The following changes to the tender documents are effective immediately and will form part of the contract documents:

END OF ADDENDUM NO. 5

PROJECT TITLE
 NORTH DISTRICT BUILDING
 RECAPITALIZATION

A-5-17 REF. DRAWING E4.1

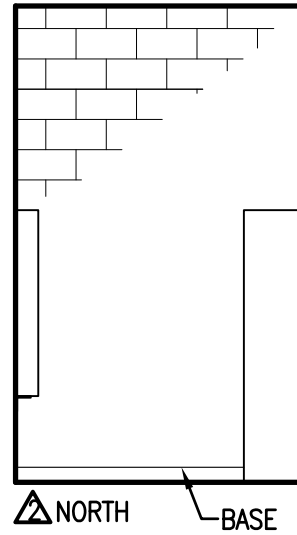
- .1 Revise note for the connection of the secondary feeders to the SPC transformer to include; ‘When the new distribution has been installed and commissioned, the contractor shall coordinate the connection of the new secondary feeders to the secondary terminals of the existing transformer with SaskPower so that the existing cables and new cables are both terminated on the transformer terminals and both are operational. The existing cables shall remain energized until the existing distribution is de-commissioned in the next tender package. Contractor shall coordinate shut down with SaskPower and the Departmental Representative.’

AR4.1

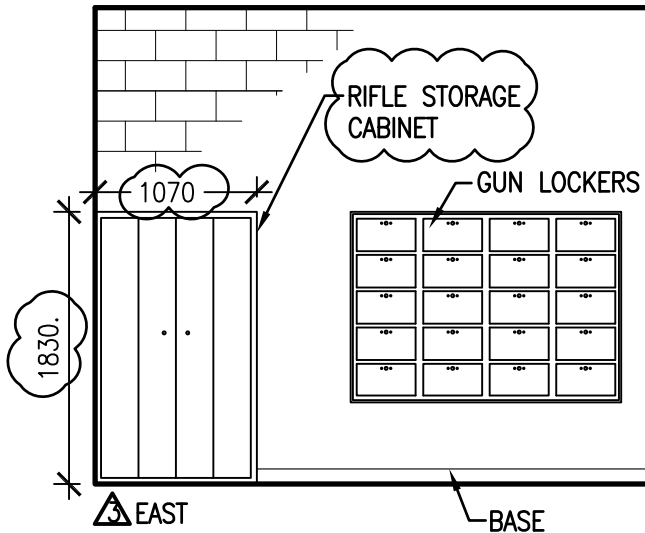
- 2.4.2.5 Revise to Read: “Size: Suitable for 15 long guns – dimensions as noted on drawings.”

- .1 Reference Detail 10 – East Elevation:
.1 Revise elevations as per drawing AR4.1 attached to this addendum.
